# EHN1 Cryogenics Integration

# NP-02 Proximity Cryogenics

## Integration Report

# NP-02 Proximity Cryogenics

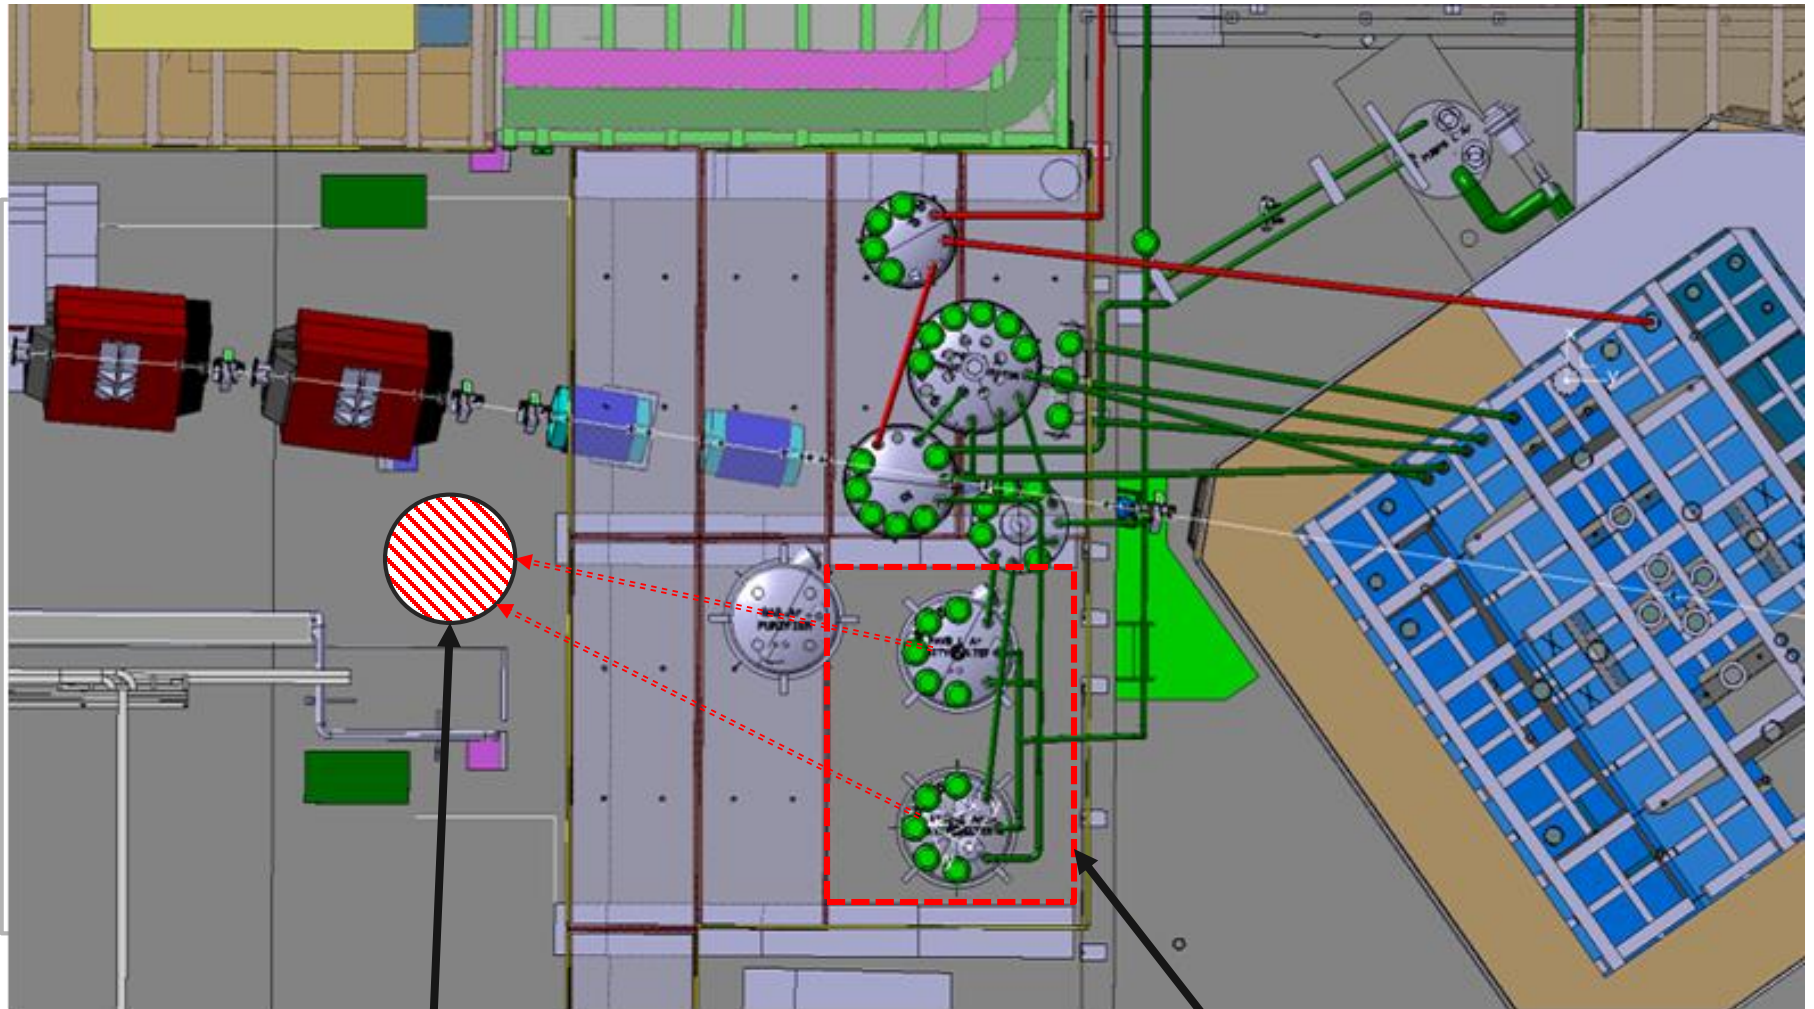
FILTER EXTRACTION ZONE

PLATFORM AREA

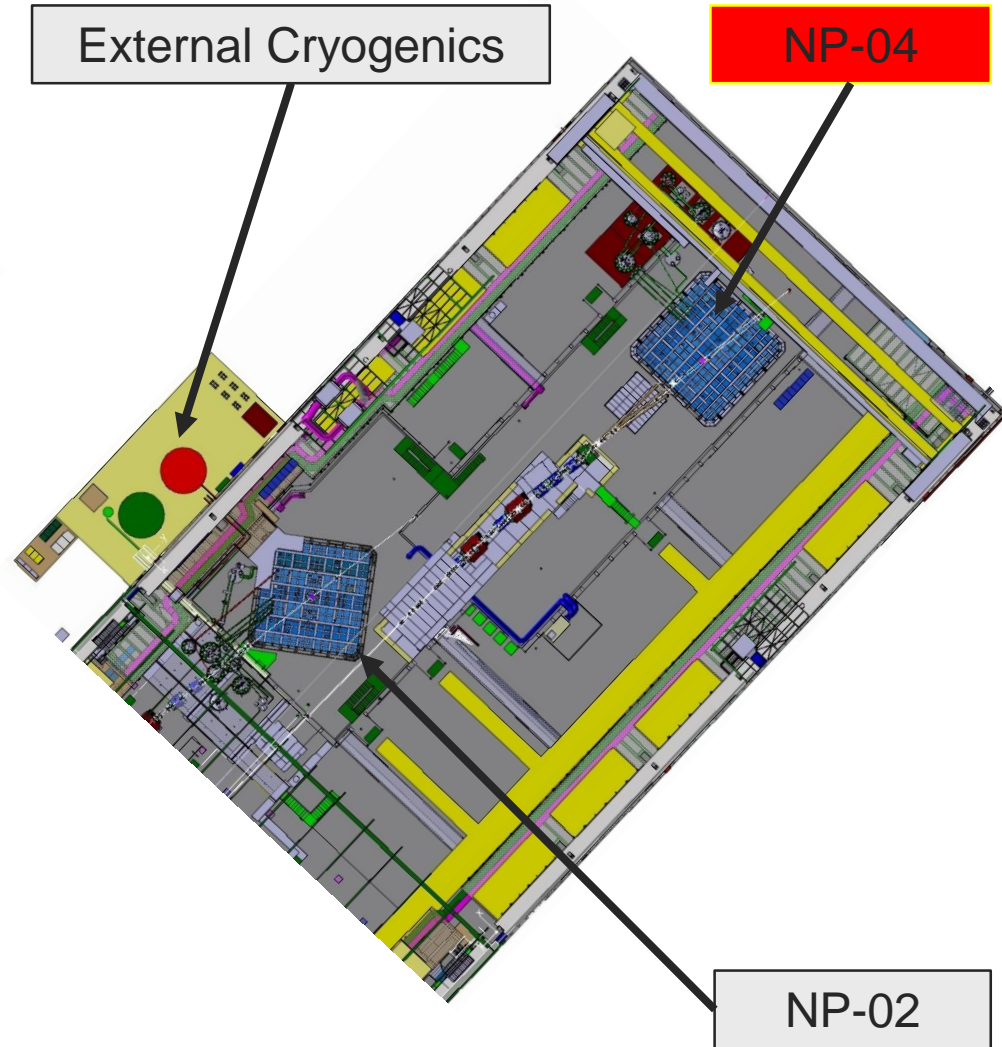
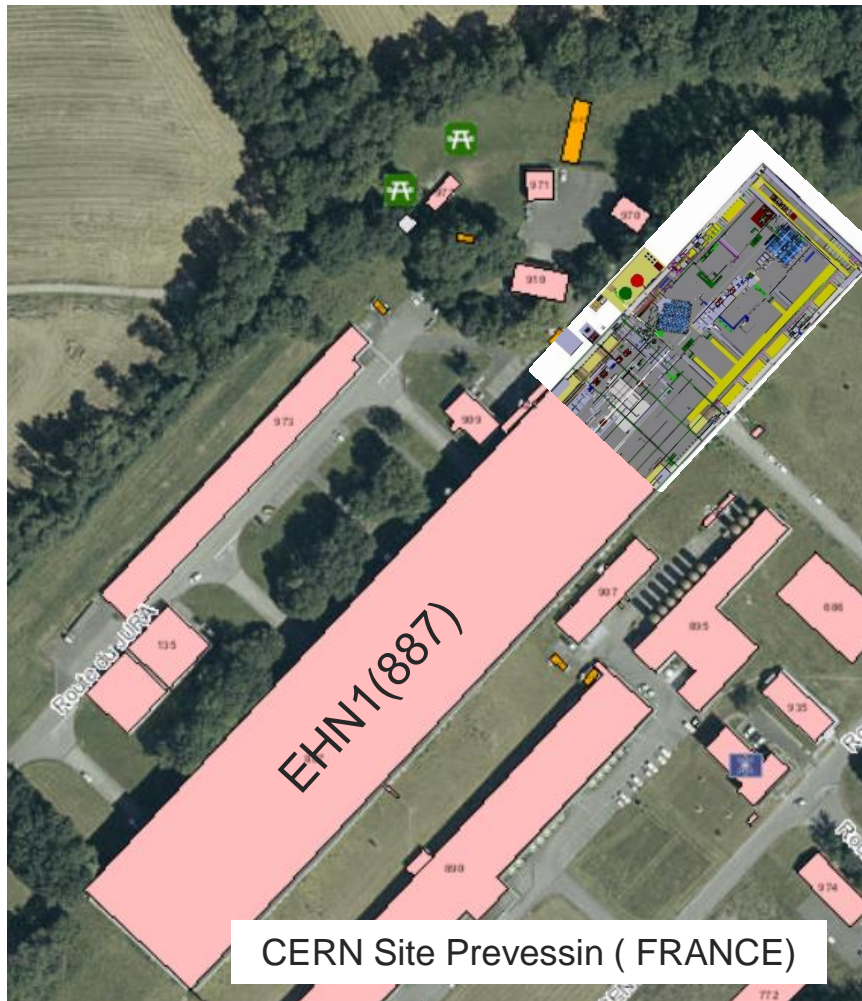
- 1
  - Filter Removal: extraction of concrete boards and integration of platform to support the chemical filters
  - Modifications in utilities routing to allow safe handling of filters in the beam floor
  - Crane cabin exclusion zone required
- 2
  - Best effort to adapt supply lines to the external cryogenics layout
- 3
  - Adaptation of supply lines to allow access platform to the cryostat top
  - Definition of no pass zone after cryogenic liquid discharge pipes
- 4
  - Proximity cryogenics allows the removal of all close beam magnets
- 5
  - Proximity cryogenics does not interfere with the experiment assembly
- 6
  - Extraction of concrete blocks near beam reported to RP

## Integration Report

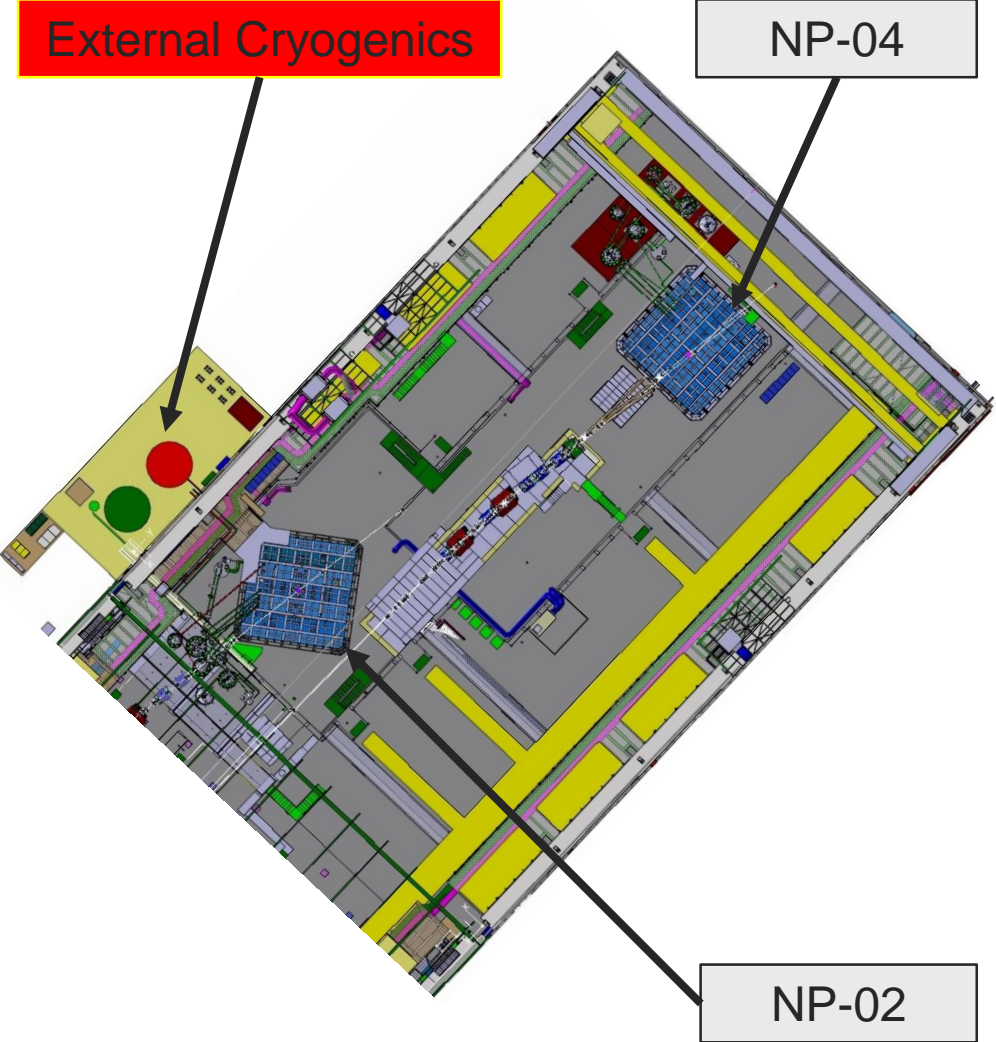
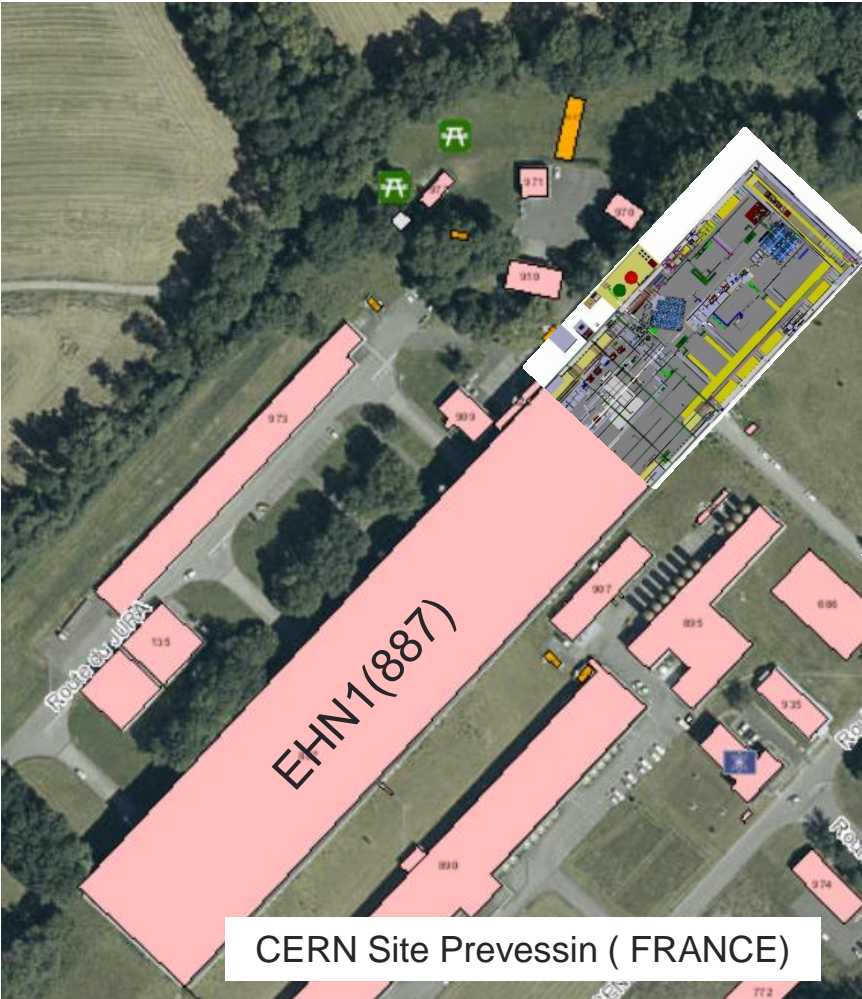
- 1
  - Filter Removal: integration of dedicated platform for filter removal
  - Best effort to route supply lines through EHN1 extension
  - Crane cabin exclusion zone required
- 2
  - Best effort to adapt supply lines to the external cryogenics layout
- 3
  - Definition of no virtual pass zone after cryogenic liquid discharge pipes ( to date, pass zones in the cryostat are not defined )
- 4
  - Proximity cryogenics have no interaction with beam magnets
- 5
  - Proximity cryogenics does not interfere with the experiment assembly
- 6
  - No relevant RP interaction reported

# Crane Clearance

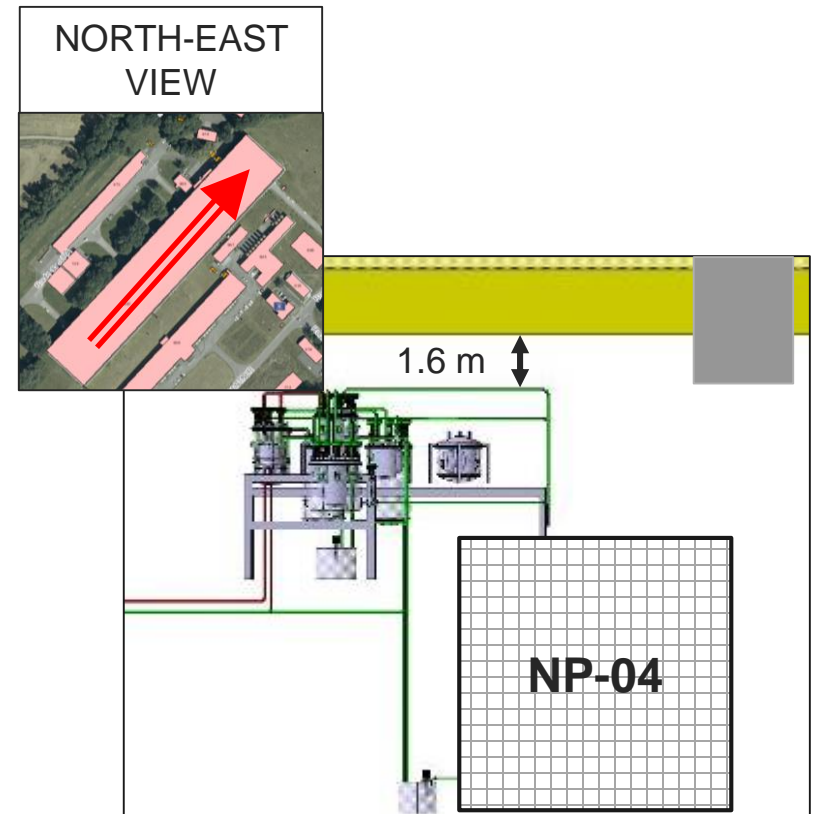
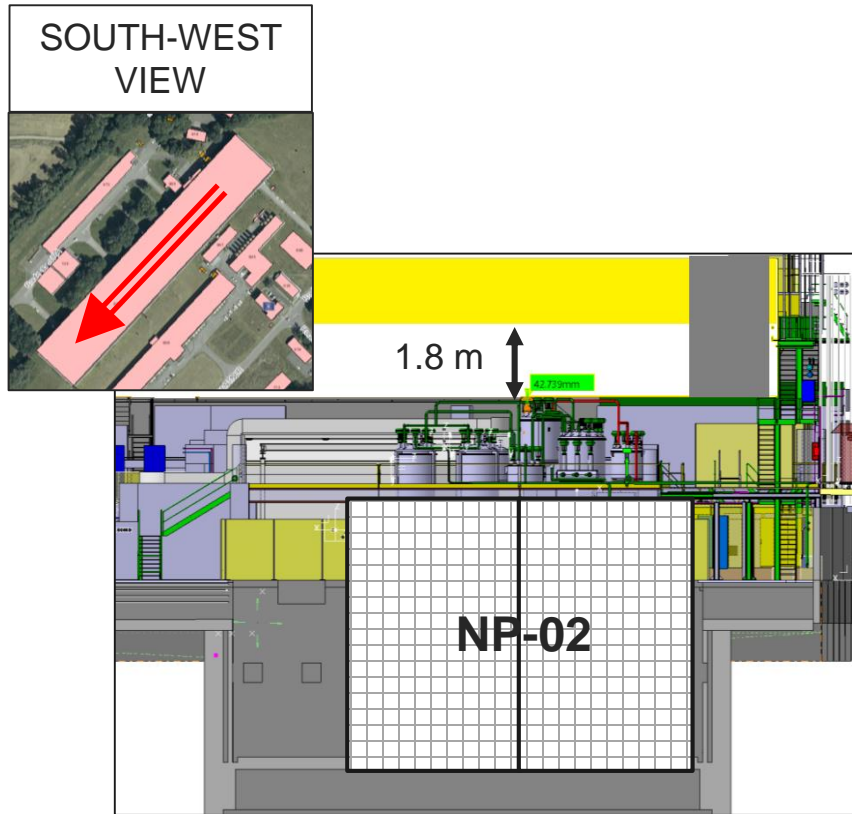
**CRANE CABIN EXCLUSION ZONE REQUIRED FOR NP-02 AND NP-04**
